18 FEDERAL AGENCIES

Palmdale - Burbank - RECORD #4027 DETAIL

The U.S. Department of the Interior (Department) including the U.S. Fish and Wildlife Service (Service) and the National Park Service (NPS) has reviewed the *California High-Speed Rail Authority Palmdale to Burbank Project Section Draft Environmental Impact Report/Environmental Impact Statement* (DEIR/DEIS), dated August 2022. We provide the comments below pursuant to the Fish and Wildlife Coordination Act (16 U.S.C. 661 et seq.) and Section 4(f) of the Department of Transportation Act of 1966. The comments are consistent with the intent of the National Environmental Policy Act of 1969; the Clean Water Act; and the Migratory Bird Treaty Act. We are also responsible for administering the Endangered Species Act of 1973 (Act), as amended (16 U.S.C. 1531 et seq.). This information is being provided to assist you in making an informed decision regarding site selection, project design, and compliance with applicable laws, including the Endangered Species Act.

Figure 1 –Wildlife Movement Opportunities, Looking North from Agua Dulce Canyon Road, through the Linkage Design, Across the SR 14 Freeway Corridor and Roadkill Data

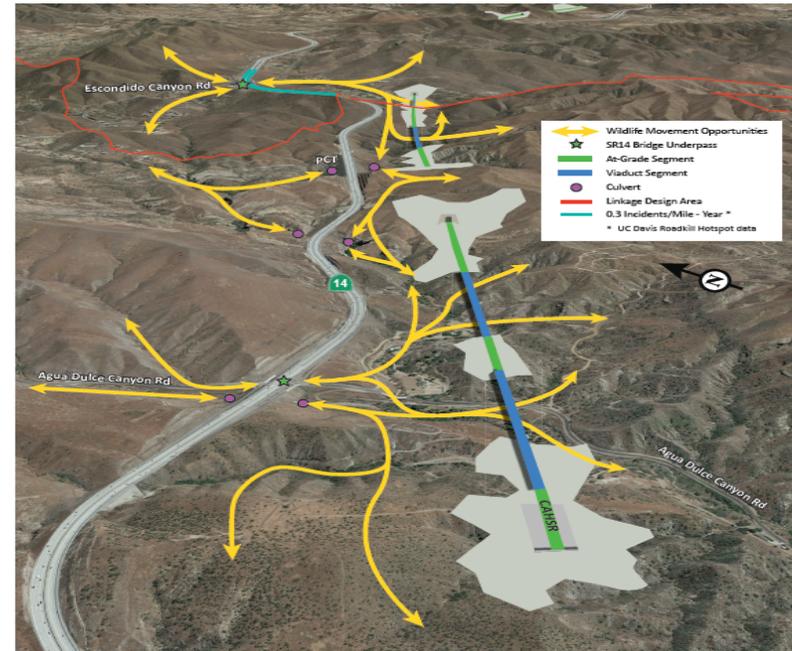
The commenter suggests the majority of available wildlife crossings will be associated with the viaducts, tunnels, and additional wildlife crossings are part of the built design and align with the existing bridge structures on the SR 14 freeway and high use crossing areas documented by UC Davis roadkill data, illustrated in Figures 1 and 2. Lastly, the commenter notes the viaducts, tunnels and culverts constructed for the build alignment alternatives may be underutilized by wildlife. Regarding concerns about wildlife crossings, the length and spacing of the tunnels and viaducts dispersed throughout the project will provide opportunities for wildlife species to move across a diversity of habitat types including upland, drainage, and riparian. The proposed design features including tunnels and viaducts would provide opportunities for wildlife movement. Refer to Standard Response PB-Response-BIO-3: Wildlife Movement Corridors, for additional information.
